UNITED STATES
NUCLEAR REGULATORY COMMISSION
WASHINGTON, D.C. 20555-0001
February 10, 2000

LICENSEE: Omaha Public Power District
FACILITY: Fort Calhoun Station, Unit No. 1
SUBJECT: MEETING SUMMARY - ABB-CE REPORT CEN-636, REV. 0 AND JAPANESE DATA FOR RT_{PTS} DETERMINATION

**Meeting with NRC to Discuss
Reactor Vessel Integrity Options for
Current and Renewed License Terms**

Figure 2
Effect of T_{cold} on SRM Data
HSST Plate 01 Results (CF=130.3 F)

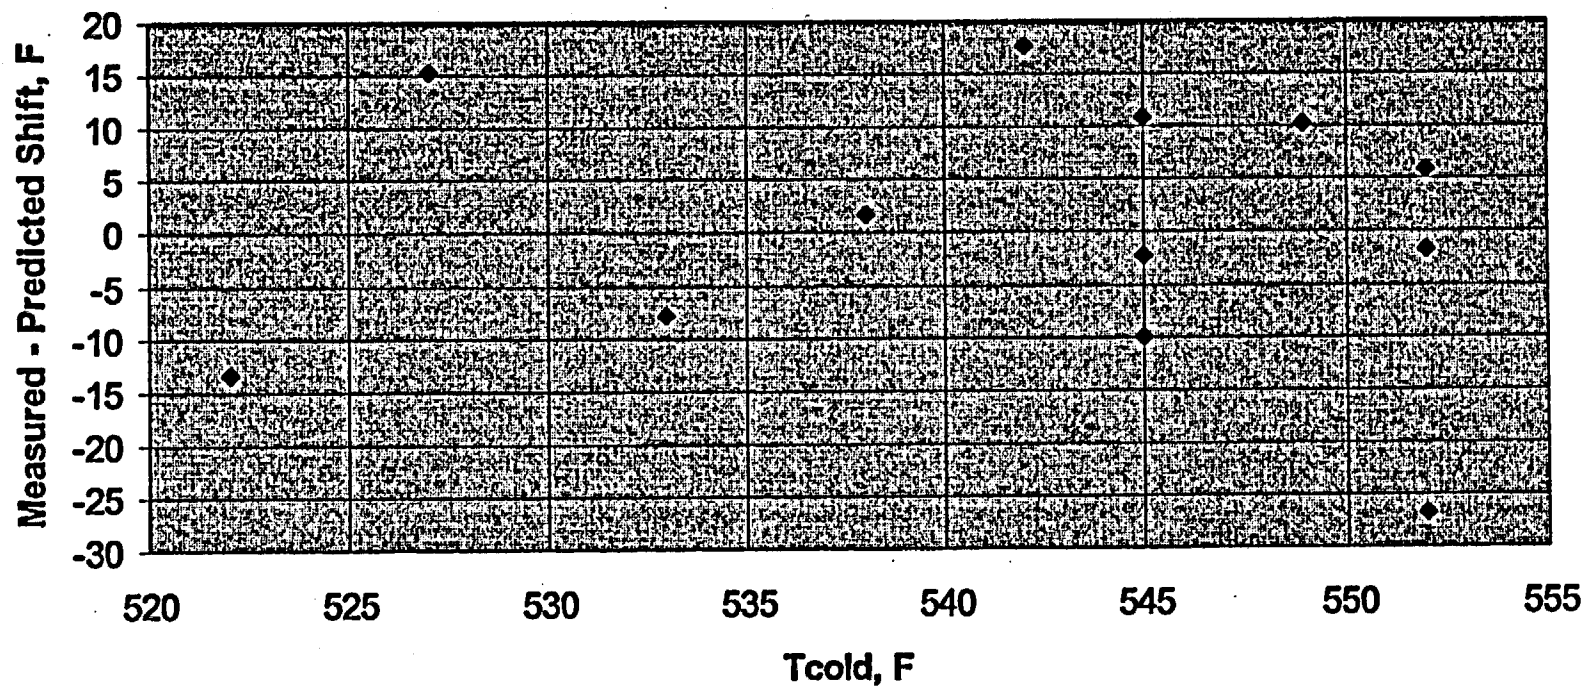
- *Treatment of irradiation environment- data are from W plants and were irradiated at 533 °F - 557 °F vs. Fort Calhoun at 527 °F - 538 °F*
- Response:
 - Surveillance data for FCS are a time averaged value of 527°F - 538°F, and current value is 543°F. Time-averaged value of approximately 540°F.

- Response to treatment of irradiation environment (continued):
 - Most relevant W data were at at 537°F - 542°F
 - CEN-636 showed no discernible effect on HSST 01 over range 522°F - 552°F; two FCS measurements included

- Response to treatment of irradiation environment (continued):
 - Conclusion: data and analysis of CEN-636 presently justify that no temperature correction is needed. Will clarify in Revision 1 of CEN-636.
